## 7714 YONGE STREET, THORNHILL HERITAGE CONSERVATION DISTRICT

RENOVATION OF EXISTING HERITAGE HOUSE, AND REAR  
ADDITION AT 7714 YONGE STREET, THORNHILL HERITAGE  
CONSERVATION DISTRICT

Azam Khan, PhD  
7716-7724 Yonge St.  
(owner)

To the Members of Heritage Vaughan

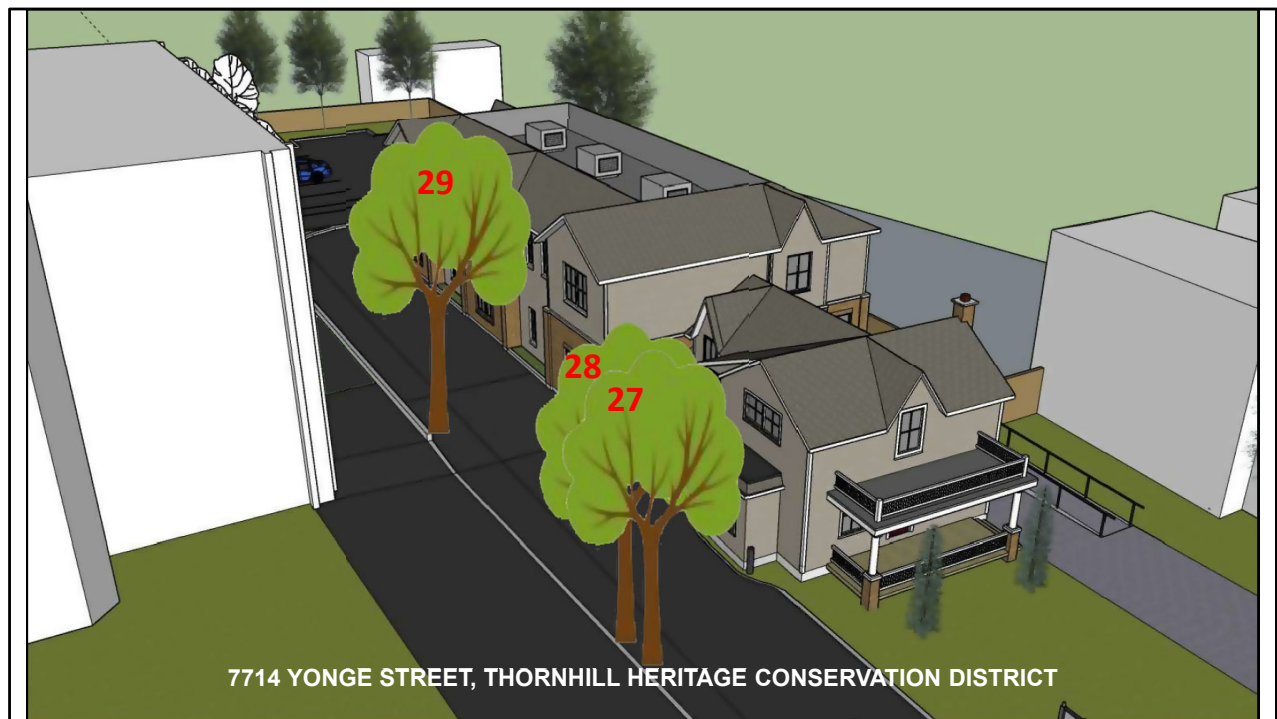
In particular, the 3 mature trees in good condition shown here are to be preserved but are not show on the 3D models.

In overlaying the 3D model, you can see the trees are not shown and the driveway area is fully paved.

If these large trees are damaged or killed, this would fundamentally alter the historic feel of the area.

From this higher angle, again the trees are not shown.

If we add in the trees that are labelled as being preserved in the arborist report, trees 27, 28, and 29, we can see that they would not have permeable ground around them which would make it unlikely that they would survive.

Also, the very large paved area is unsightly, redundant, and unsustainable.

Instead, I would like to propose that the existing driveway be shared between Bell Canada and 7714 Yonge St.

This would help preserve the trees in good health, have significant water retention of the ground to mitigate runoff and wastewater treatment, and reduce snow shovelling and salt.

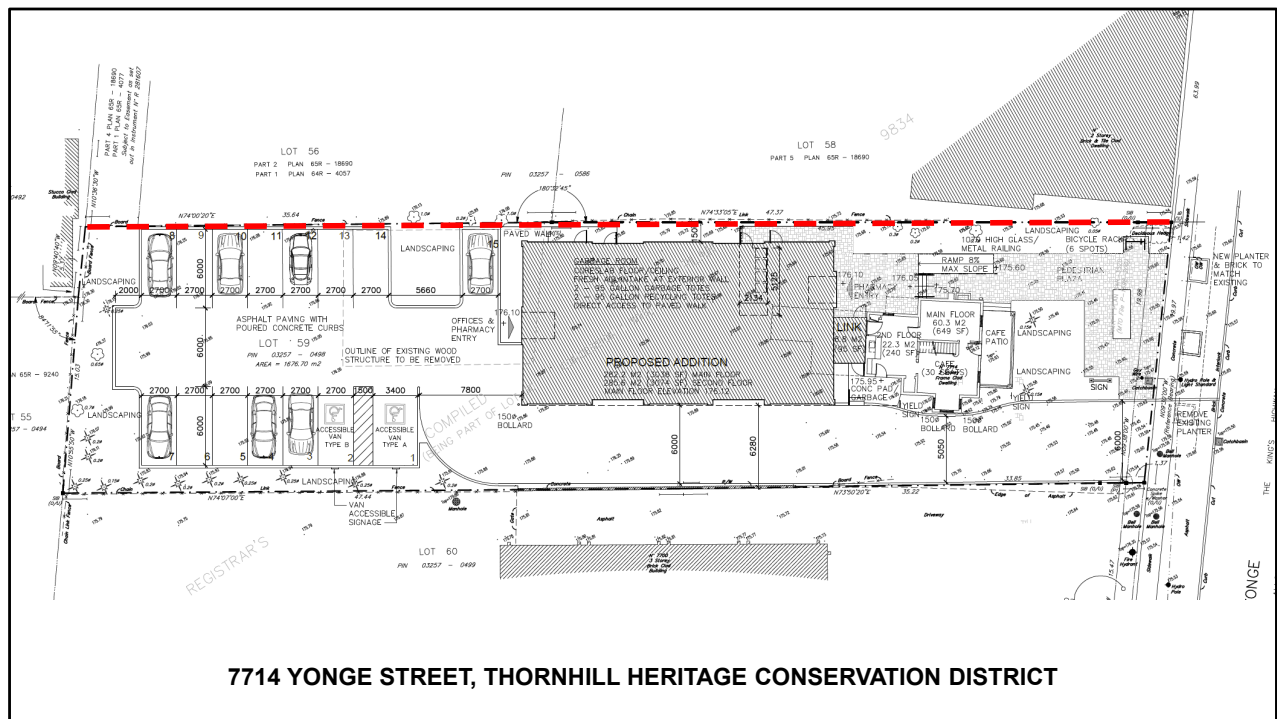
Going back to the high-angle view, please note the error marked with a red X to the right. It shows a fence attached to my building.

This cannot be allowed as it would heavily encroach on to my property and I already have a path there, not to mention the large historic trees.

As the property line extends linearly from the corner of their proposed parking lot, many part of this drawing encroach and I will not allow on my property.

I think we can all agree that the property line is a completely straight line and that the 3D visualization is incorrect.

This mean that this image should be corrected or marked as being incorrect.

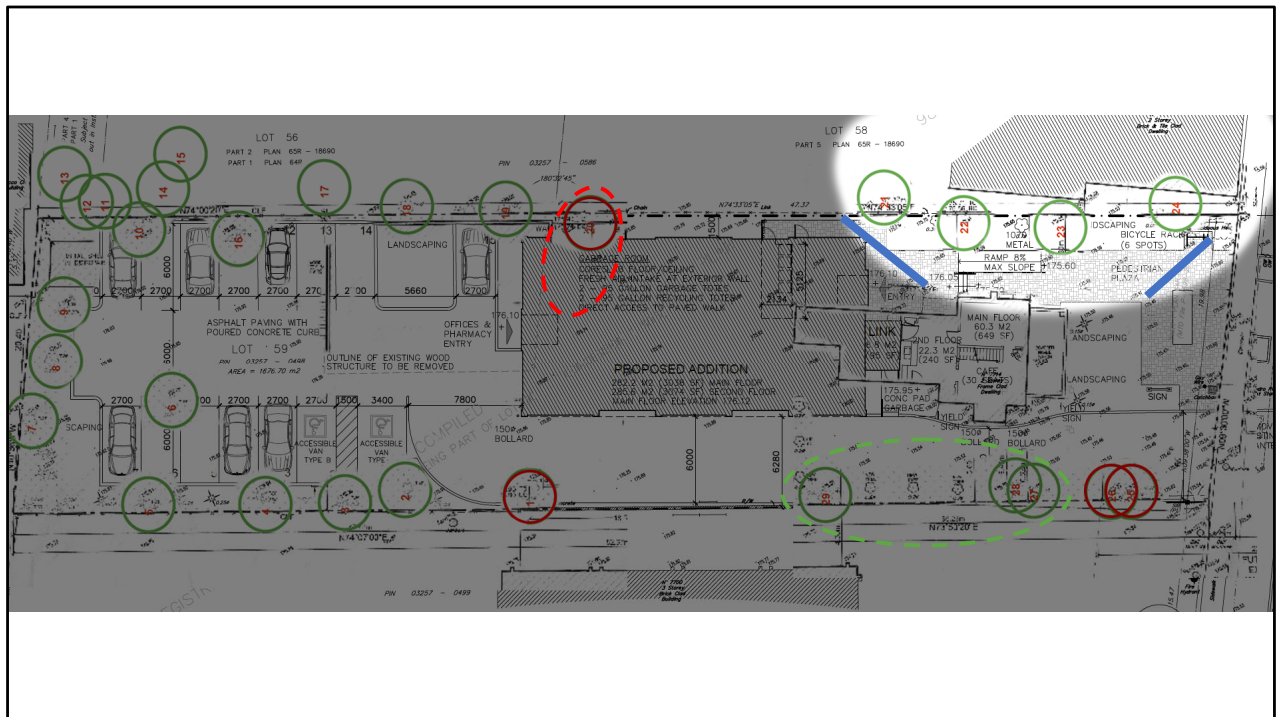
Finally, the demolition and construction phase is concerning. While I’m happy to see “hand demolish” for some parts, the allowance of hydraulic equipment requiring vibration monitoring with danger to the foundation, is concerning especially as my building is so close.

As stated here, the vibration monitoring is unacceptable as it only notifies designated recipients after it is too late.

As both the Stark house and my building, Francis Block, are very old, we need a strategy of prevention, not monitoring and later repair or destruction. Therefore, I request that the concrete barrier proposed on Page 266, be extended to both sides of the existing driveway.

Please consider methods for PREVENTION as it may be impossible to recover lost historic aspects of these properties.

This zone need protection as otherwise there will certainly be unrecoverable damage.

This is because, as you can see, any construction vehicle coming to the site will believe this is the access pathway to the new construction at the rear of the property. This will certainly damage the trees and vibrations could damage both our foundations.

By placing concrete barriers at both ends of the current driveway, the accidents can be prevented entirely.
